STATE OF HAWAII
DEPARTMENT OF TRANSPORTATION
HIGHWAYS DIVISION

INTERSTATE ROUTE H-1
Kunia Interchange Improvements
F. A. I. Project No. 1M-HI-1(219)

SHEET No. L39 OF 52 SHEETS

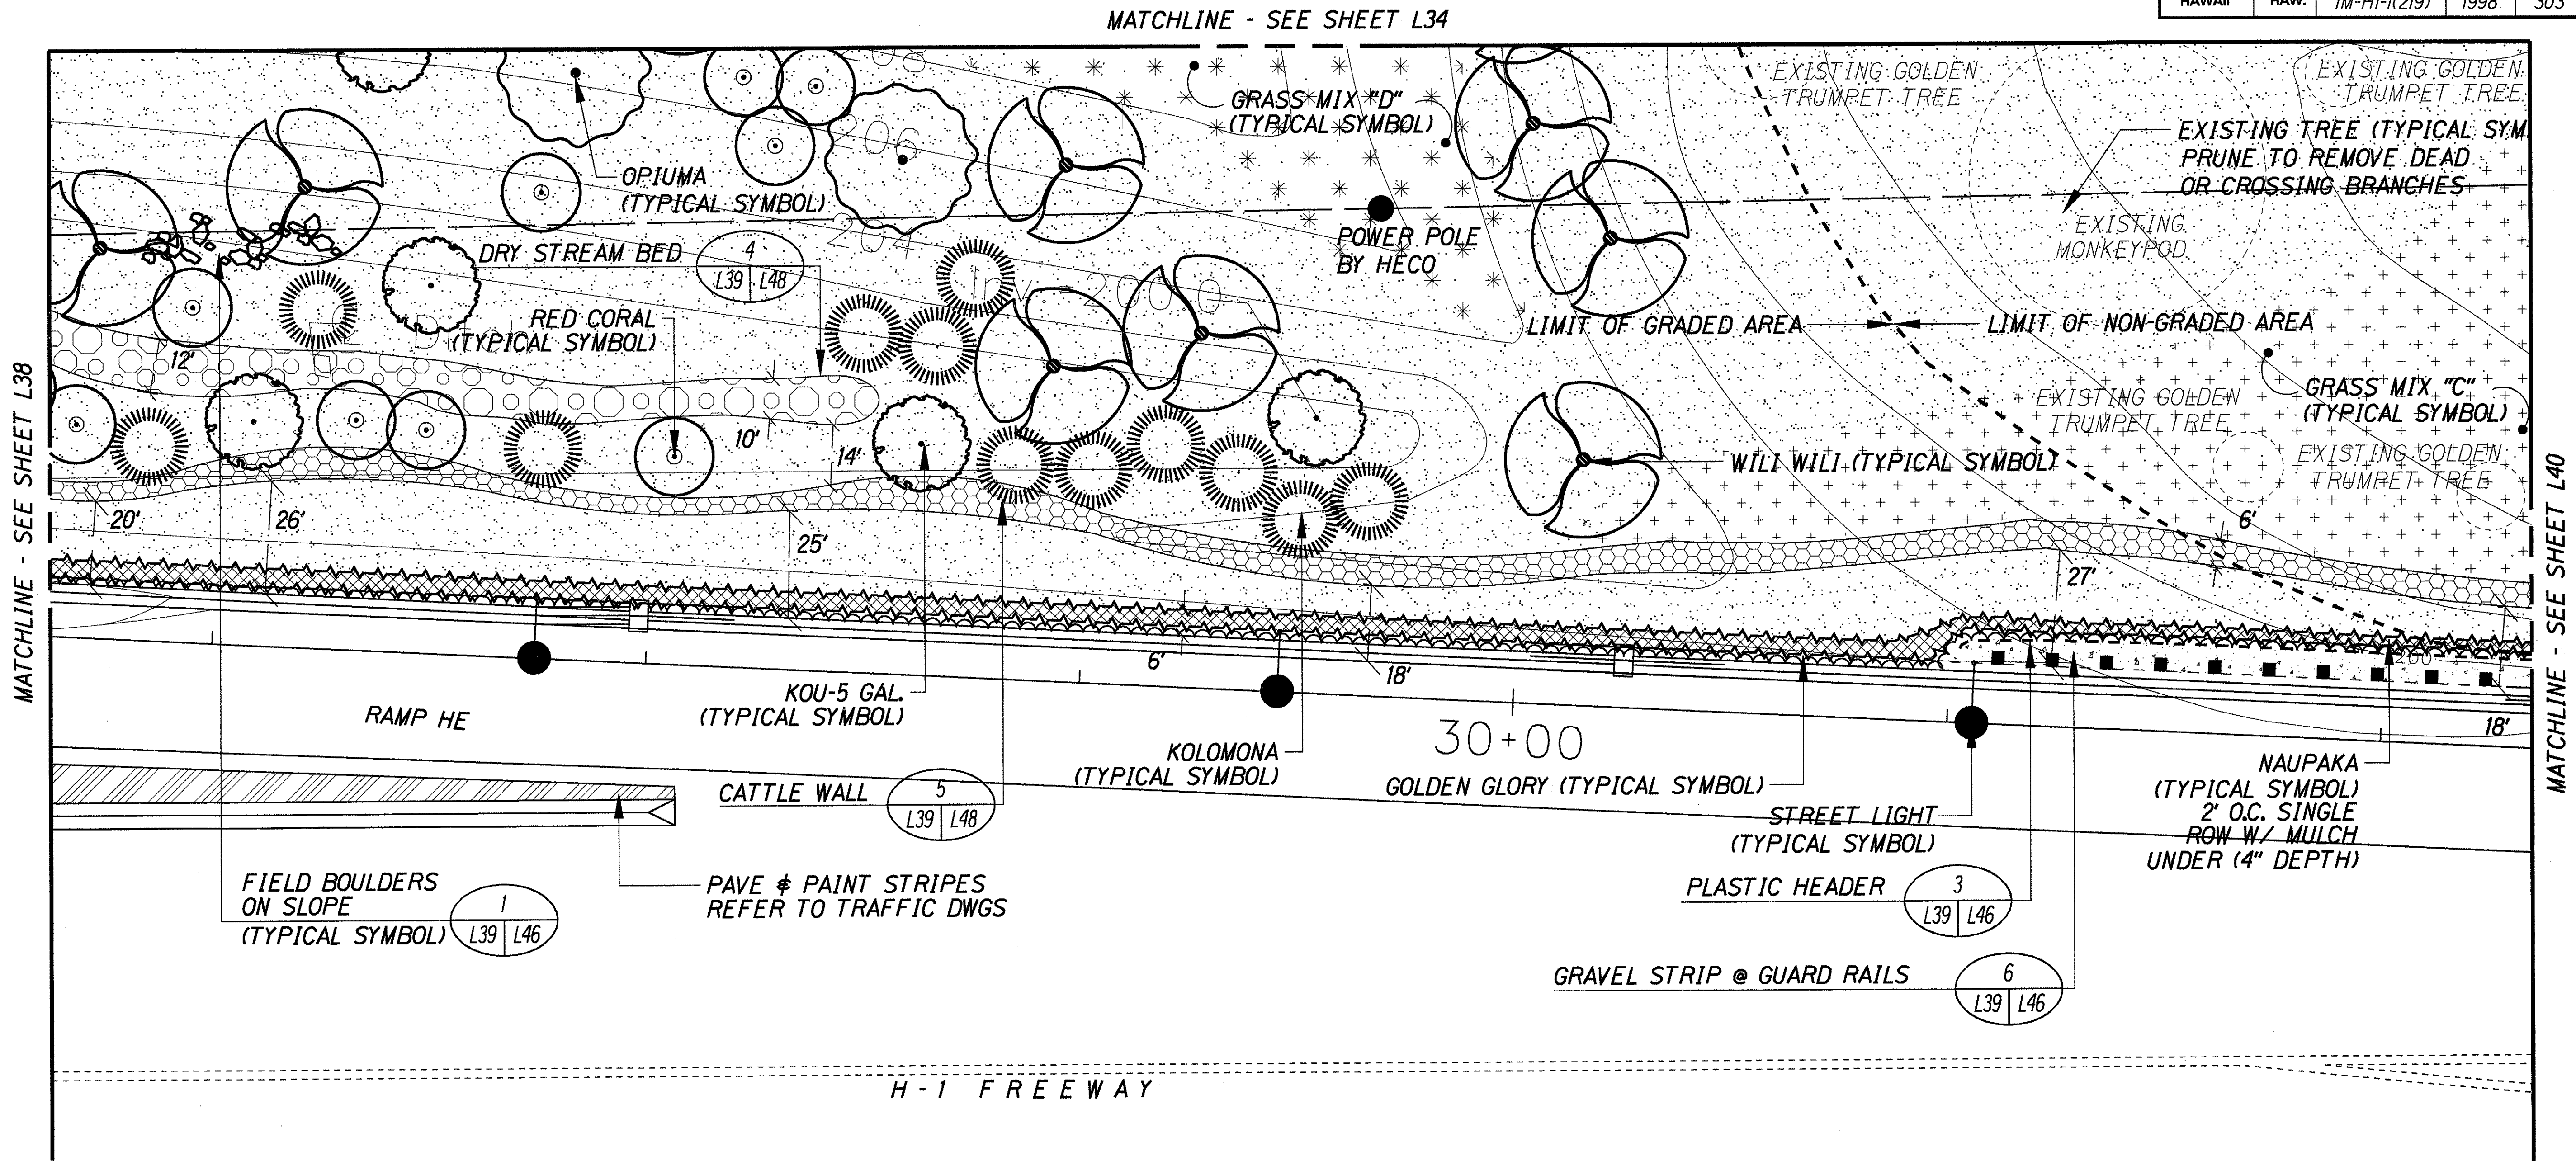
4/3/98	Revised Typical Symbol for Creeping Ilima to Read Golden Glory Per Addendum NO. 3.
DATE	REVISION

SHEET No. L40 OF 52 SHEETS

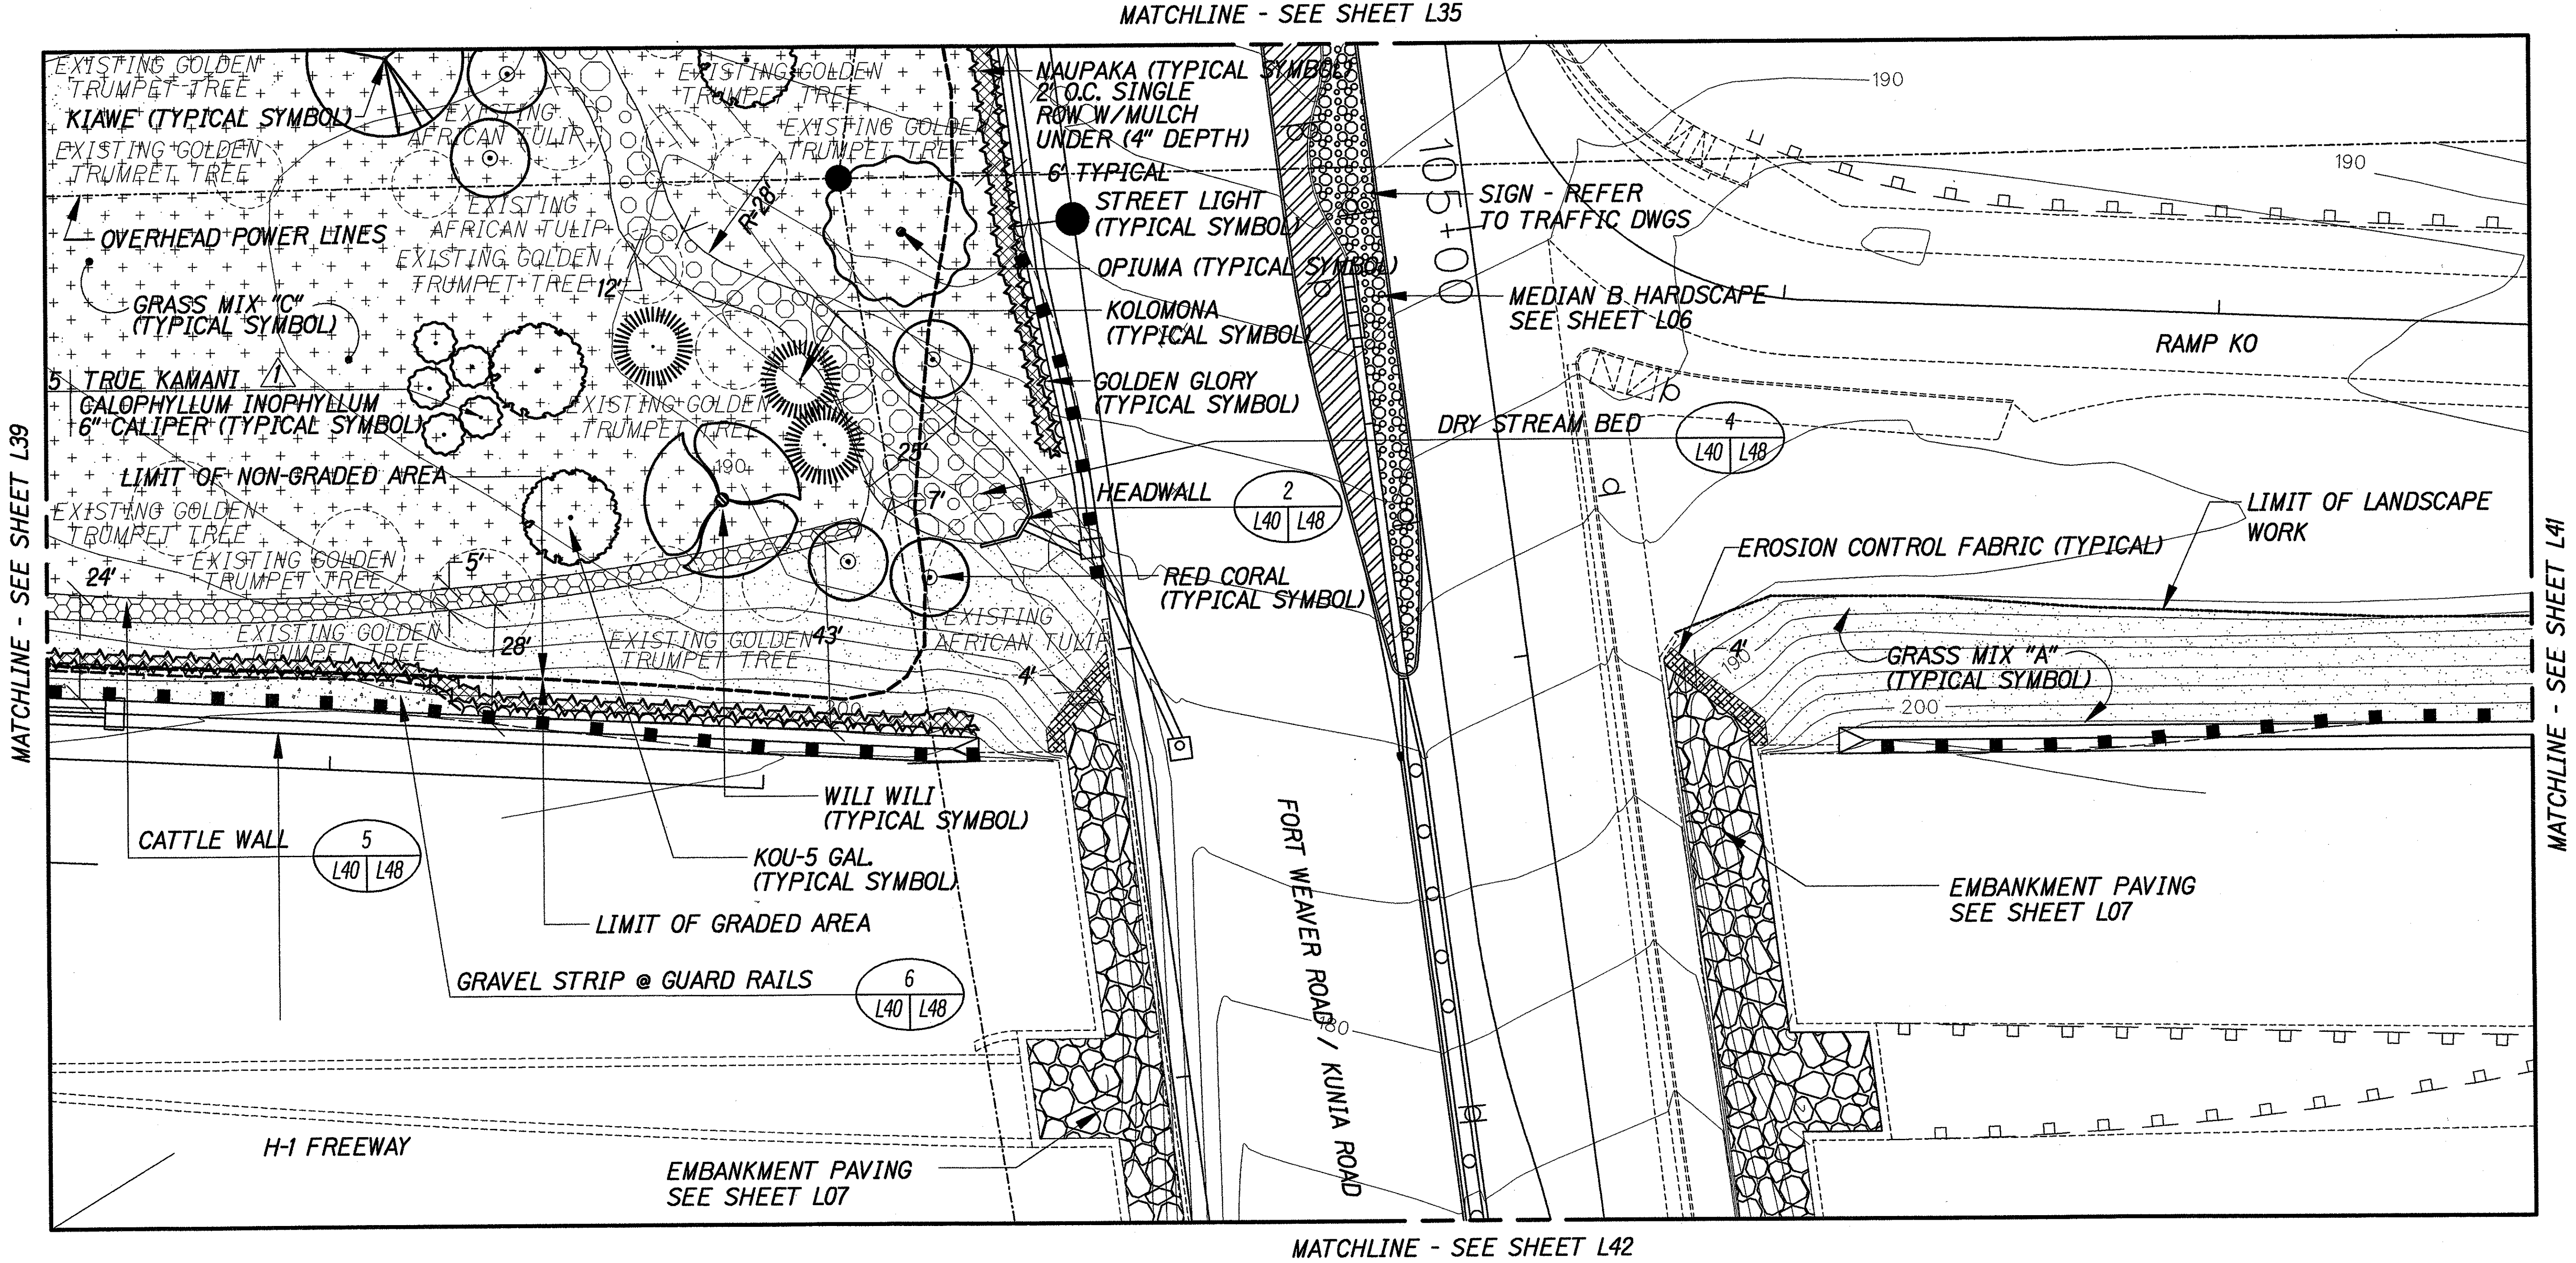
4/30/01	Revised Planting Plan
4/3/98	Revised Typical Symbol for Creeping Illima to Read Golden Glory Per Addendum No. 3.
DATE	REVISION

Scale: SHEET No. L49 OF 52 SHEETS

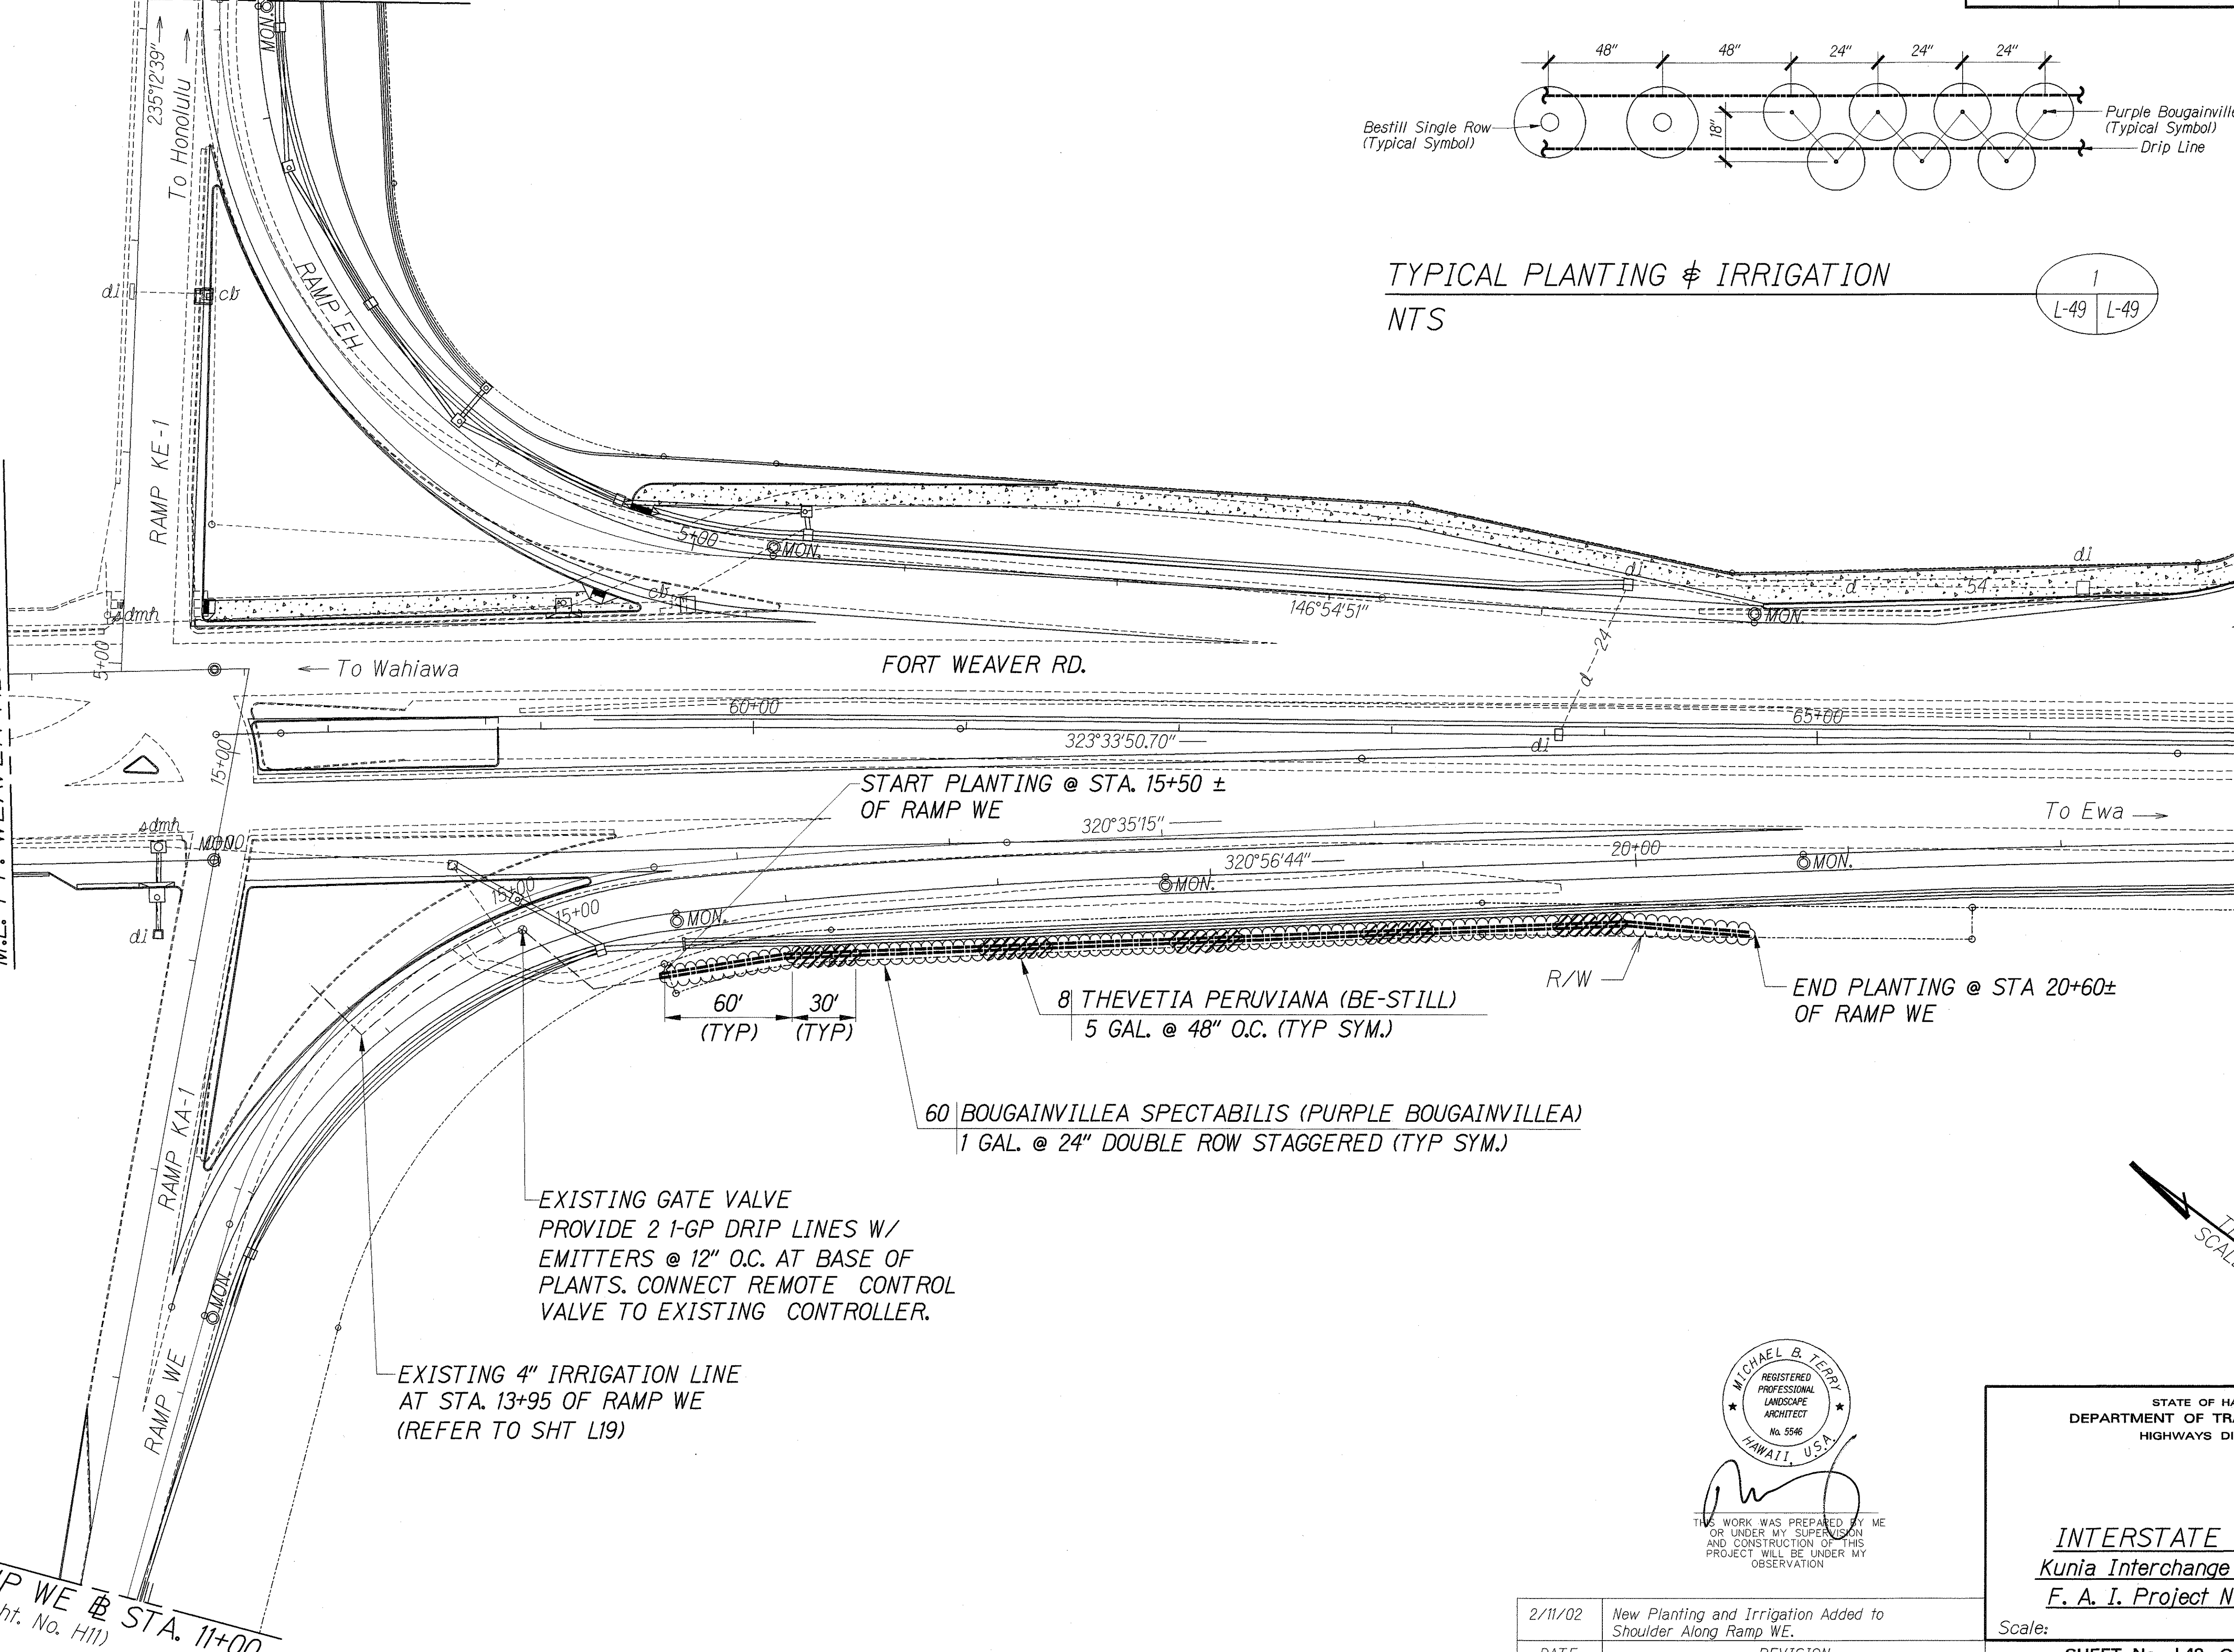
2/11/02	New Planting and Irrigation Added to Shoulder Along Ramp WE.
DATE	REVISION
